This sheet transmits Revision 01 to Service Bulletin 500-21-0001.

SB No.: 500-21-0001 PAGE: 1 of 1

AIR CONDITIONING - REPLACEMENT OF THE FLOW CONTROL SHUTOFF VALVE (FCSOV)

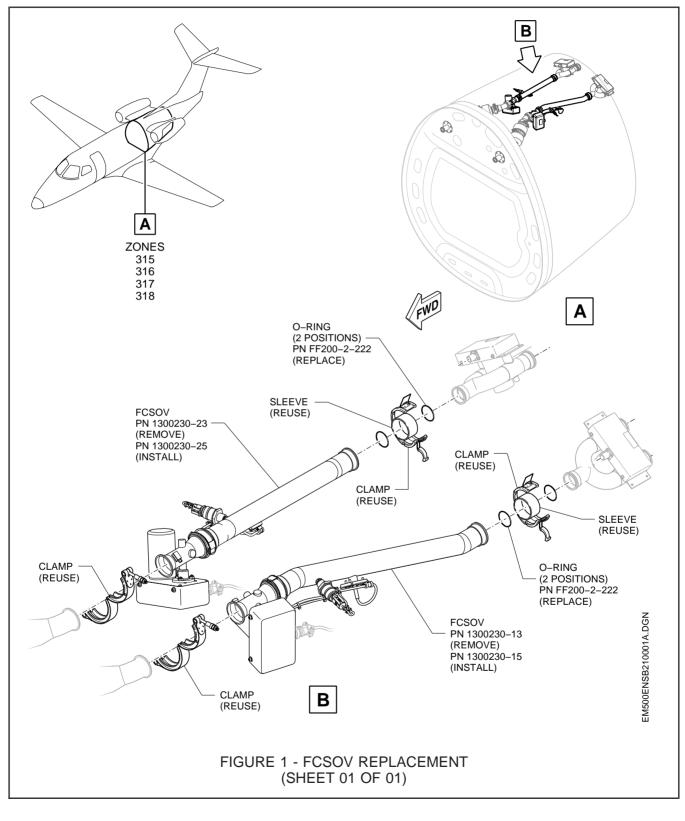
- A. Make sure that the aircraft is safe for maintenance (AMM TASK 20-00-00-910-801-A/200 Aircraft Maintenance Safety Procedures).
- B. Remove the ceiling panel 315 ALC and 316ARC according to AMM TASK 50-31-02-000-801-A/400 - Aft Baggage-Compartment Ceiling Panel - Removal.
- C. Remove the valves PN 1300230-13 and PN 1300230-23 as given in AMM TASK 21-21-01-000-801-A/400 Flow Control Shutoff Valve (FCSOV) Removal. Refer to Figure 1.

- D. Install the new valves PN 1300230-15 and PN 1300230-25 as given in AMM TASK 21-21-01-400-801-A/400 Flow Control Shutoff Valve (FCSOV) Installation, with its attachment parts saved during the removal procedure. Refer to Figure 1.
- E. Install the ceiling panel 315 ALC and 316ARC according to AMM TASK 50-31-02-400-801-A/400 - Aft Baggage-Compartment Ceiling Panel - Installation.
- F. Restore the aircraft to normal.
- G. Enter the accomplishment of this bulletin in the applicable documents.
- H. Download and fill out the "Service Bulletin Implementation and Evaluation" form in Portable Document Format (PDF) from the Flyembraer portal (<u>http://www.flyembraer.com</u>) or fill out the attached form and send it to address below:
